UNITED STATES  
DEPARTMENT OF THE INTERIOR  
BUREAU OF LAND MANAGEMENTFORM APPROVED  
OMB NO. 1004-0137  
Expires: January 31, 2018**SUNDRY NOTICES AND REPORTS ON WELLS**  
*Do not use this form for proposals to drill or to re-enter an abandoned well. Use form 3160-3 (APD) for such proposals.*5. Lease Serial No.  
NMNM120901

JABBERWOCKY 1H

**Delaware Basin  
Changes to APD/COA for Federal  
Well**

## Summary of Changes to APD Submission

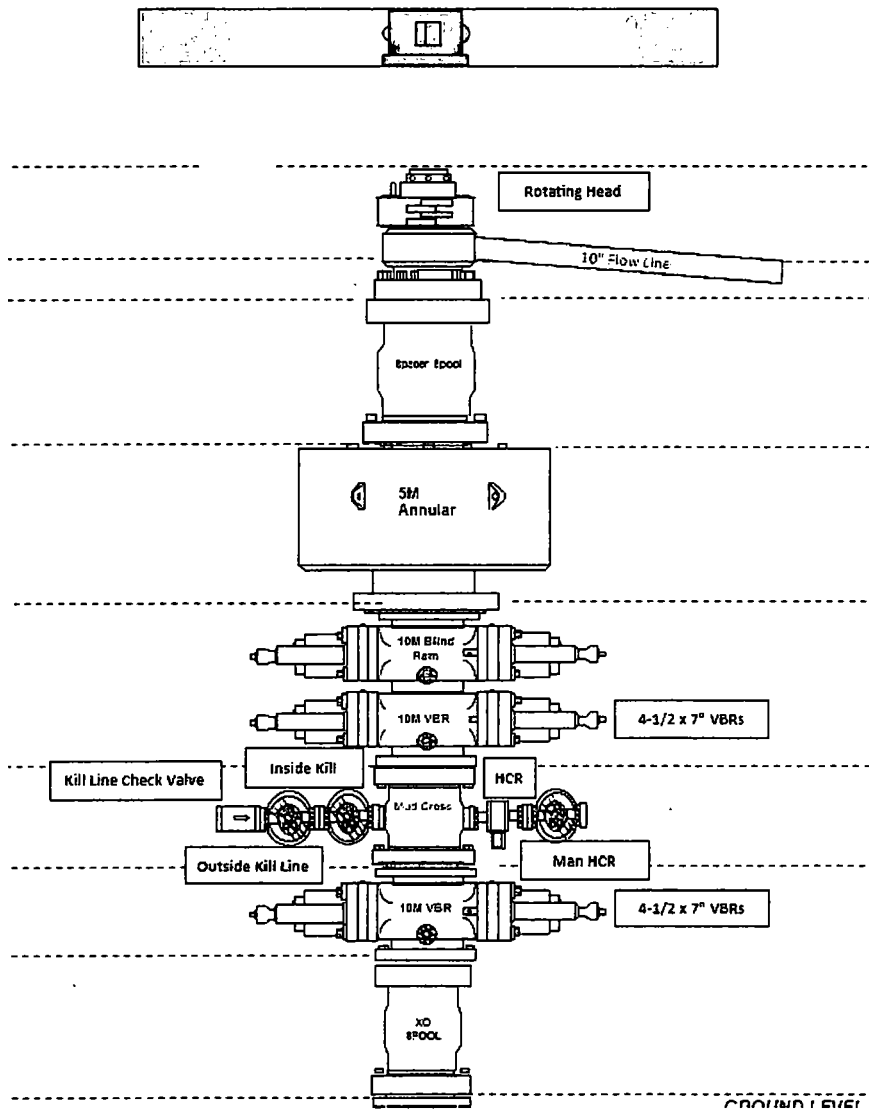
The updates to maximum MW will adjust the Anticipated surface pressure, to an estimated ~4,819 psi (at 12,750 ftTVD).

For drilling out of the intermediate shoe: The change requested is utilizing a **5M pressure rated Blowout Preventer**, which will utilize a 5M Annular tested to a minimum of 3,500 psi, two independent 10M variable bore pipe rams tested to a minimum of 5,000 psi and a single 10M blind ram tested to a minimum of 5,000 psi. (All which are in alignment with the rig up and testing sequence of the remainder of the wells on the pad, including the 250 psi low test.)
